**The Municipal Corporation of the Town of Fort Erie
Special Council Meeting
Addendum**

***8.2 PBBS-40-2025**

Proposed Official Plan and Zoning By-law Amendments Information
Report for lands located at 3856 Terrace Lane and Unassigned Parcel
0-15097 Crystal Beach Road.

Report: PBBS-40-2025

Figure 1: The development superimposed on the WWTP.

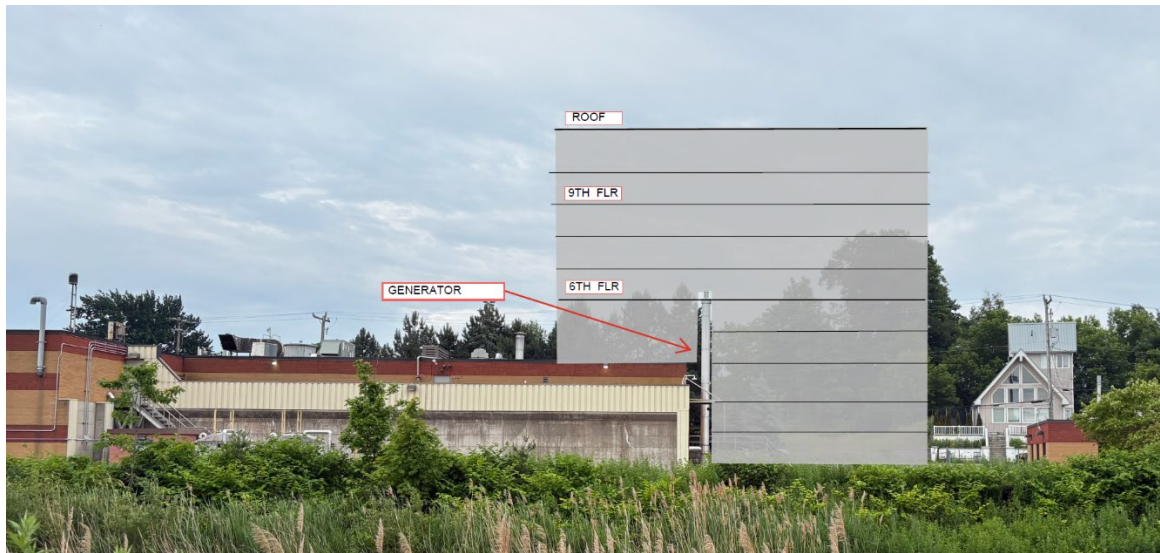
This underrepresents the potential impact. The diesel generator stack is 18 metres above grade at the WWTP, which itself sits approximately 1.5 metres below the proposed building's ground floor elevation. Therefore, the top of the stack would align roughly 16.6 metres above the proposed building's ground floor—approximately at the 6th floor level. As such, residents from the 6th floor upward would qualify as “elevated receptors” and could be exposed to emissions during periodic testing or emergency operation. This exposure warrants a more thorough evaluation than is currently presented.

See Figure 1 below.

The RWDI report’s treatment of the WWTP’s diesel generator operation is overly simplistic and does not adequately address real-world scenarios. The generator is not merely an emergency backup that operates infrequently—it is tested monthly for one hour and is relied upon during power outages. A notable example occurred during the week-long blackout that began around 3:30 p.m. on December 23, 2022. During that event, the WWTP’s emergency generator ran for approximately nine hours before failing due to a fuel shortage. This left the facility inoperable and raised significant concerns about public health and environmental protection.

Figure 2:

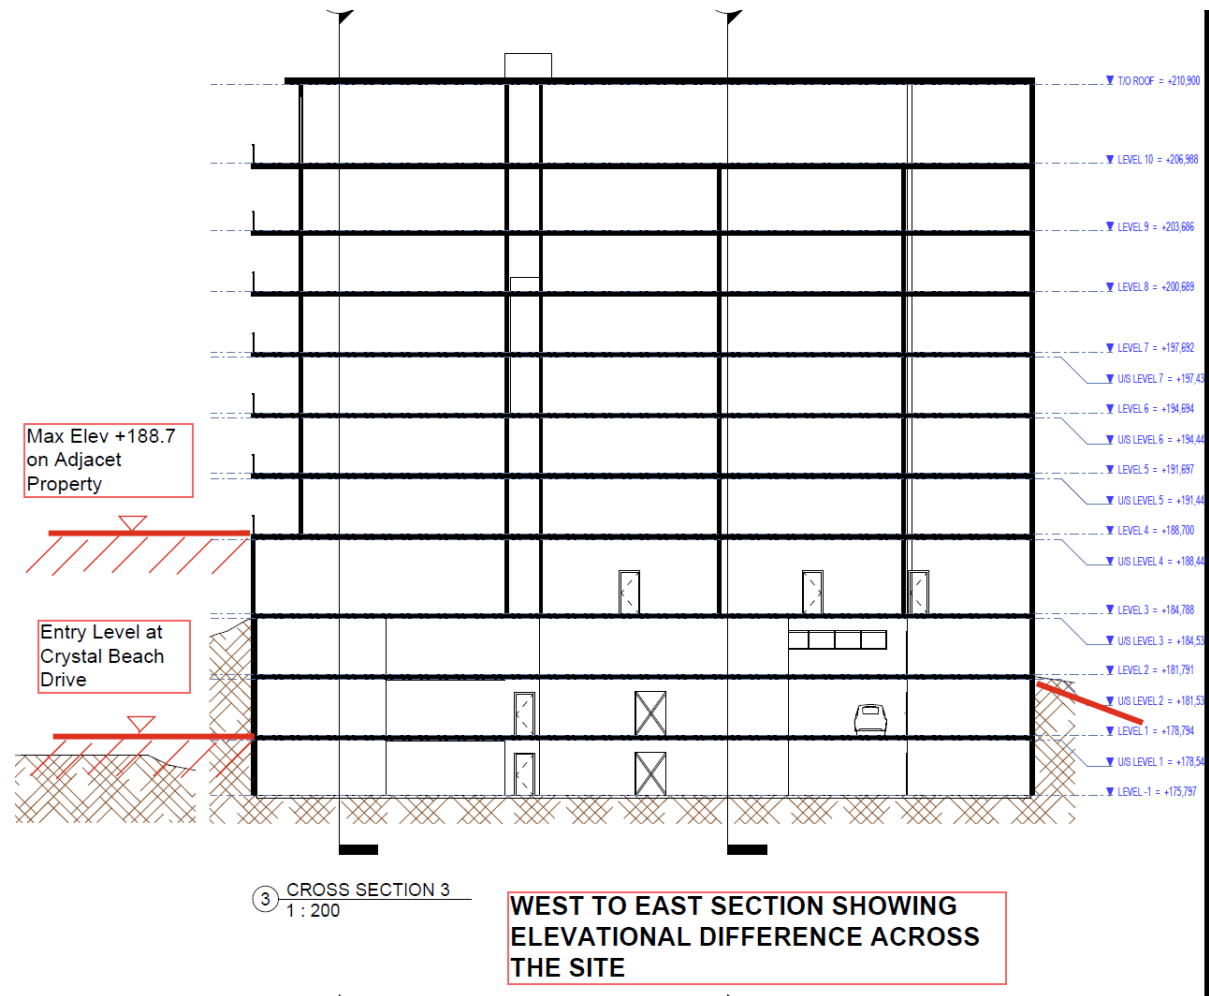
The report recognises that excavations will be to the property lines and that shoring will be required and *"the upper levels of the shoring system would have to be supported by a 'tie-back' arrangement drilled at an angle into the Cherty Limestone rock under the adjacent properties to the east and west and also under the road at Crystal Beach Drive where utilities have to be avoided."* Alternately, should permission for tie-backs be refused by the adjacent property owners then a temporary raker and waler system of shoring within the confines of the property under development will be necessary, but would have to be removed when the concrete floors slabs are completed and have attained their specified strength.

Lateral soil pressure increases with depth so the lateral pressure from the west will be greater than the lateral pressure from the east which act facing each other. Tie-backs resist the lateral forces on each side. In the absence of tie-backs the unequal forces in opposite directions must be resisted by the structure and this would require significant east-west concrete shear walls which are not account for in the floor plans and would impede circulation within the below grade parking level and the first three floors above grade. See Figures 2 and 3 below.

SKETCH
PREPARED FOR SEVERANCE APPLICATION
PART OF LOT 10
PLAN 369
IN THE
TOWN OF FORT ERIE
REGIONAL MUNICIPALITY OF NIAGARA
SCALE 1 : 200 (METRIC)

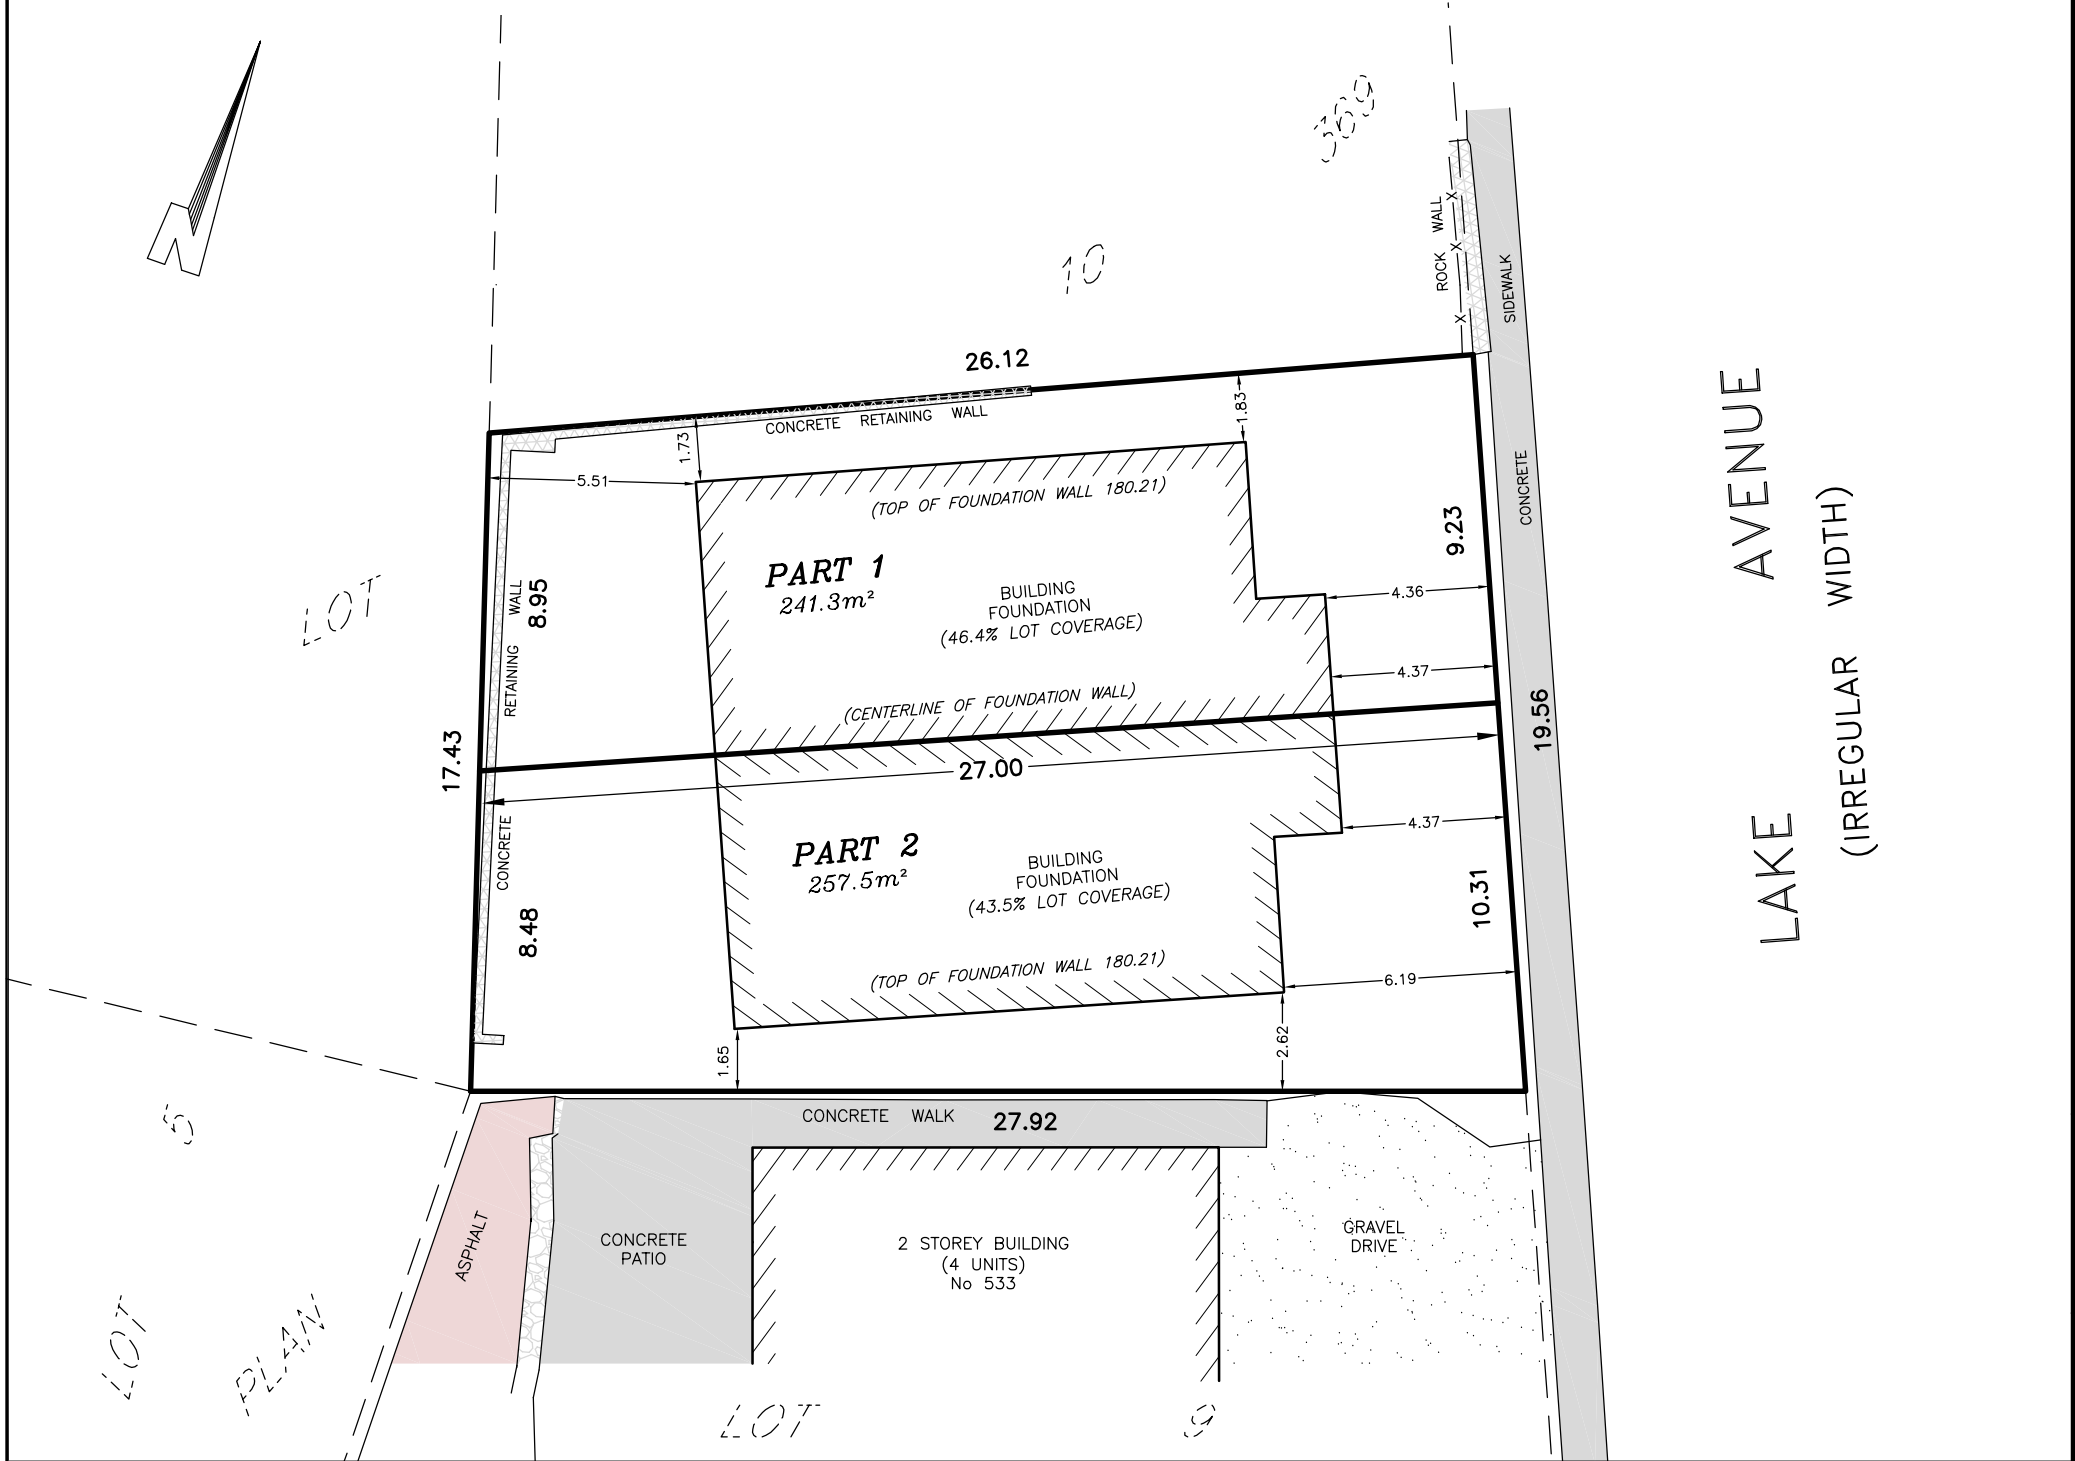
Dune height to ground surface	7.739m (25.39ft)
Dune height to foundation slab	13.56m (44.49ft)
Height at fence to ground surface	6.379m (20.987ft)
Height at fence to floor slab	12.2m (40m)

The 0.9m setback isn't wide enough for a swale and retaining wall
 Removing the sand dune will adversely impact the adjacent residential lots
